Subject: AP1000 COL Standard Technical Report Submittal of APP-GW-GLN-131 (TR 131),
Revision 1

Title: Miscellaneous AP1000 Design Changes

Technical Report 131 addresses a few miscellaneous design changes made to AP1000 that are incorporated into Revision 16 of the Design Control Document.

Figure 9.5.1-1 (Sheet 3 of 3)

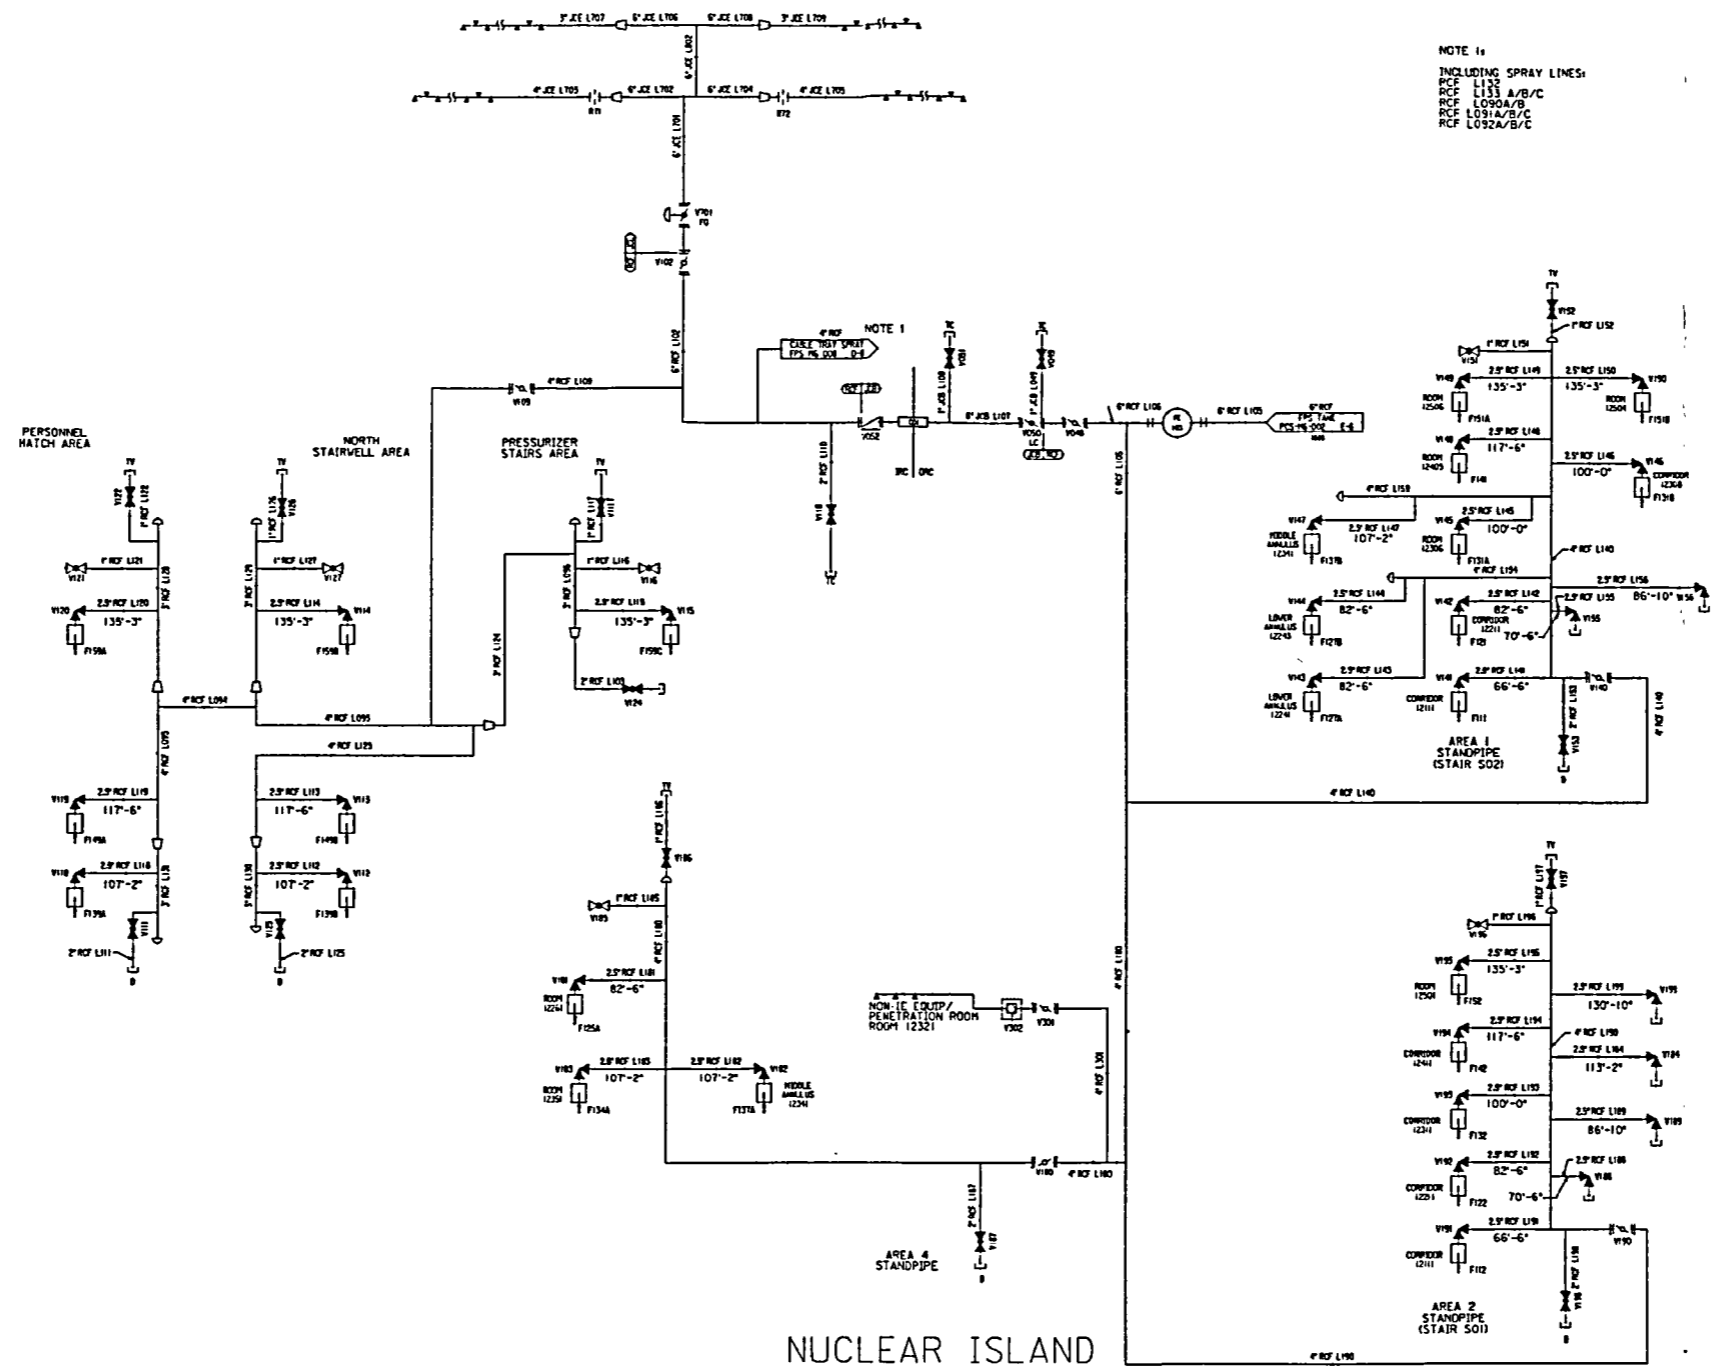
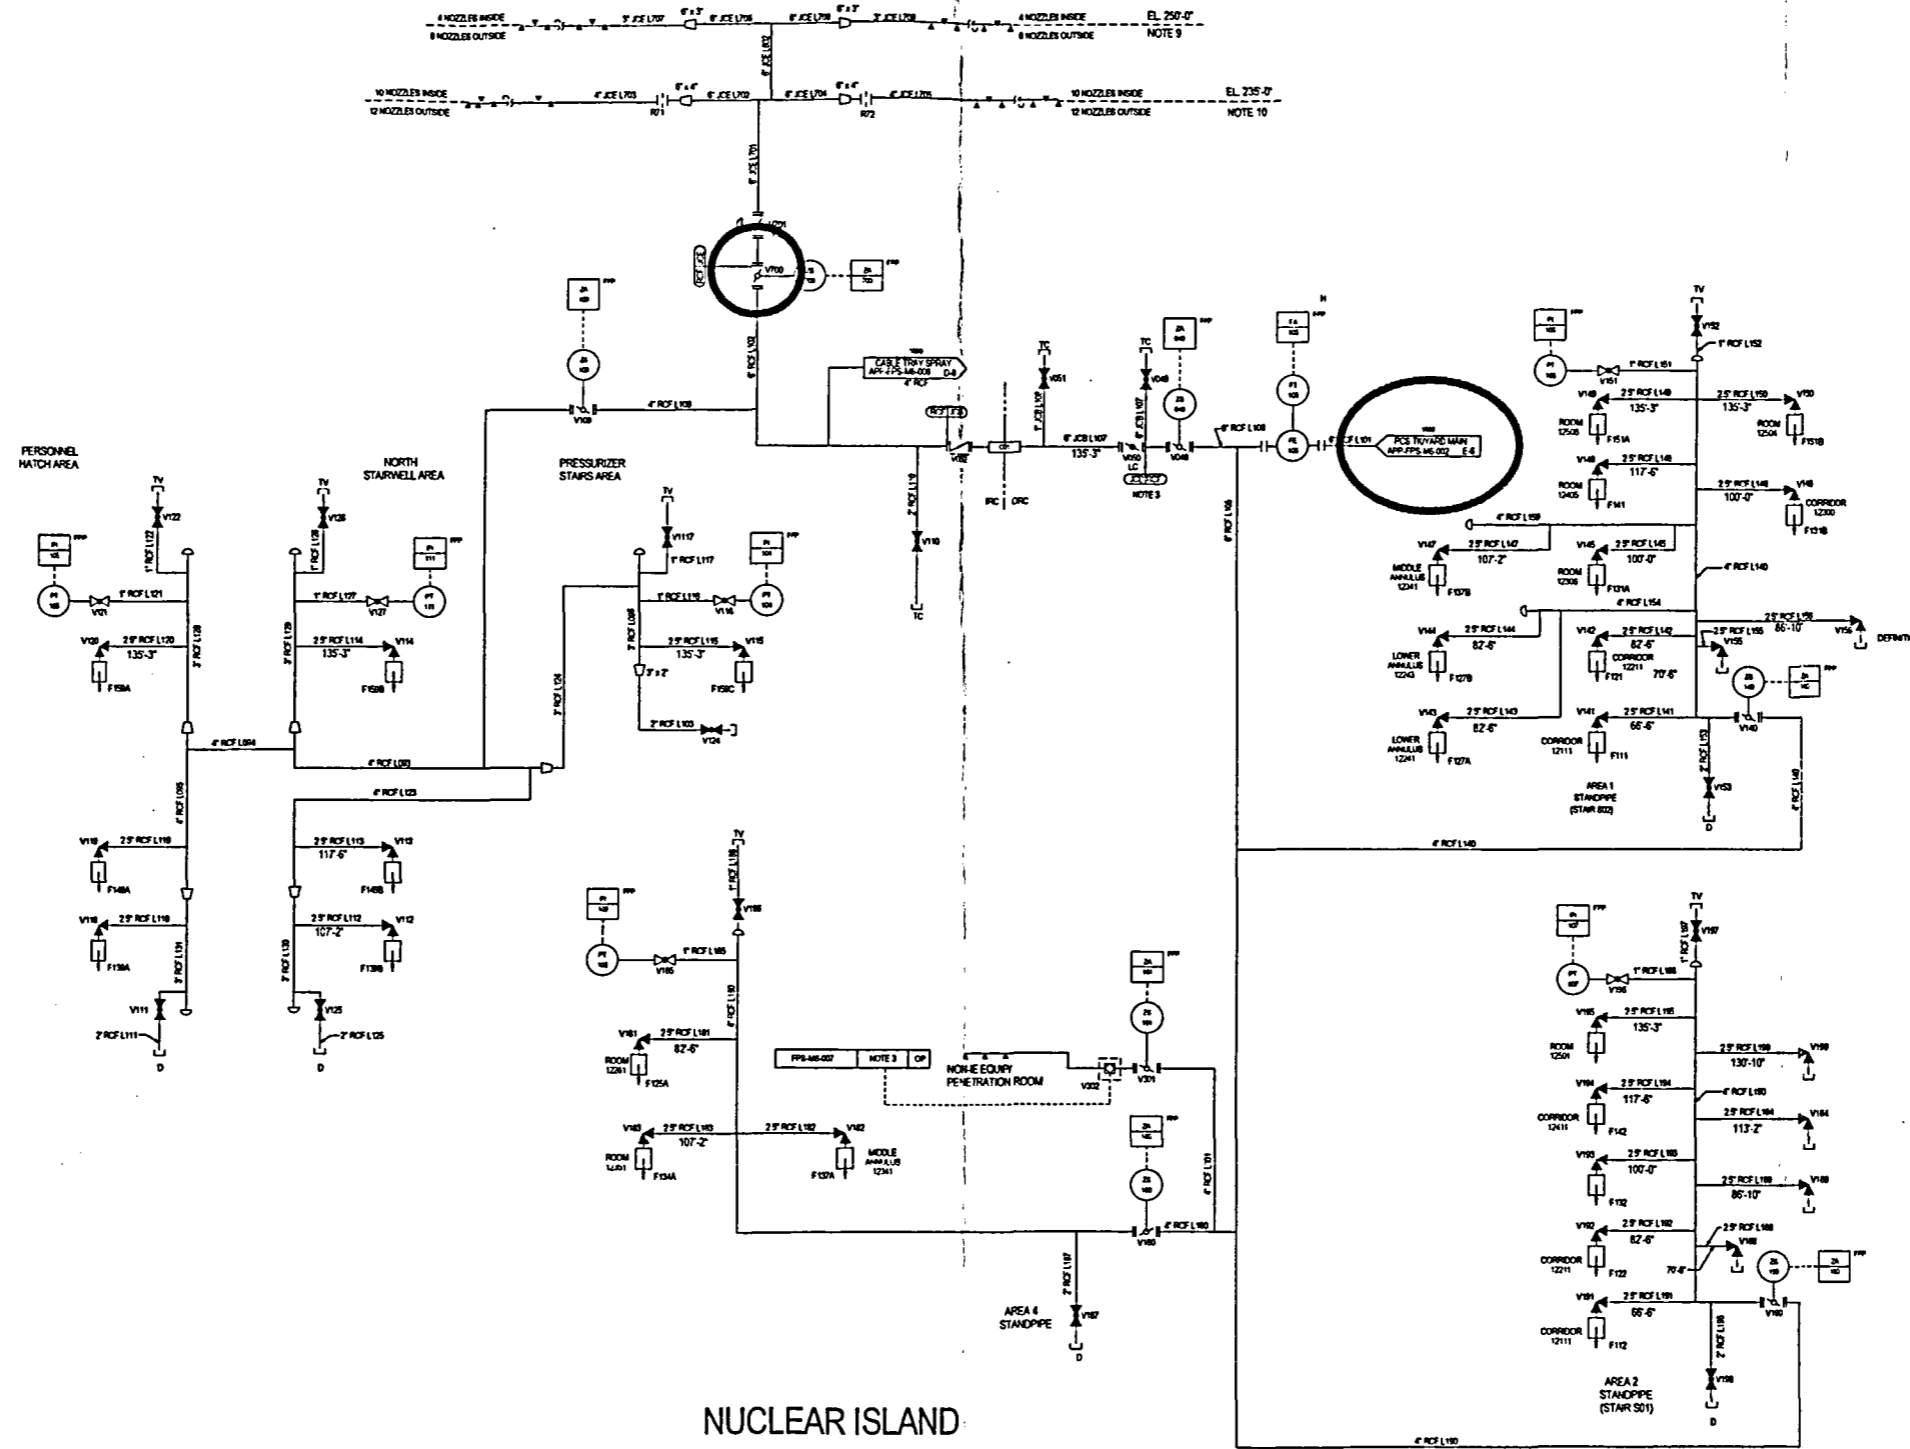
Change 7: Correction to Sheet 3 of Figure 9.5.1-1

- Valve V102 is incorrectly labeled, it should be valve V700
- Flag coming from "FPS TANK" is changed to show its correct origin
